CERTIFICATE OF APPROPRIATENESS

Property: 1248 Harvard Street, W 76.25' of Lot 24 & Lot 23B, Block 188, Houston Heights Subdivision. The property includes a 3,143 square foot, two-story wood frame single-family residence on a 5,537 square foot corner lot.

Proposal: Alteration – Construct an 858 square foot two story addition on the south side of the noncontributing residence.

NORTH SIDE ELEVATION

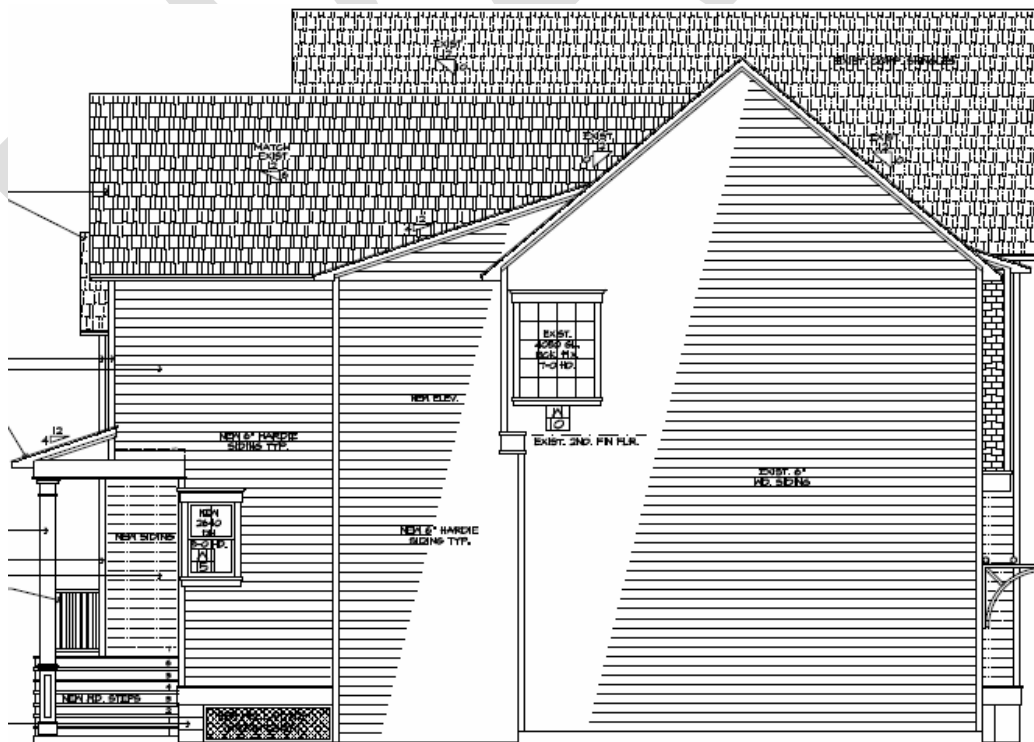
This structure is a non-contributing residence recently constructed during the 21st century and while it is not truly historical, it does include many of the major historical visual elements found in the HHEHD. I do not object to the additional area being proposed as that is one of the benefits of having a non-contributing structure – you are not trying to maintain the integrity of a historic structure, but the significant area of proposed replacement of the existing siding on the structure with new hardi-shingles is not in keeping with the character of the elements of the HHEHD. While I encourage the distinction made in the offsetting of the addition from the original structure, the replacement of a simple element of plain siding with multiple shingle areas is not supportable.

Therefore, in light of the addition of more complex elements, which is not in character with the simplistic visual character of the historic district, I OPPOSE the granting of a Certificate of Appropriateness for this property. I could support a Certificate of Appropriateness with the condition that the addition of the hardi-shingle replacements not be allowed as this is not in character with the contributing historic elements of the HHEHD.
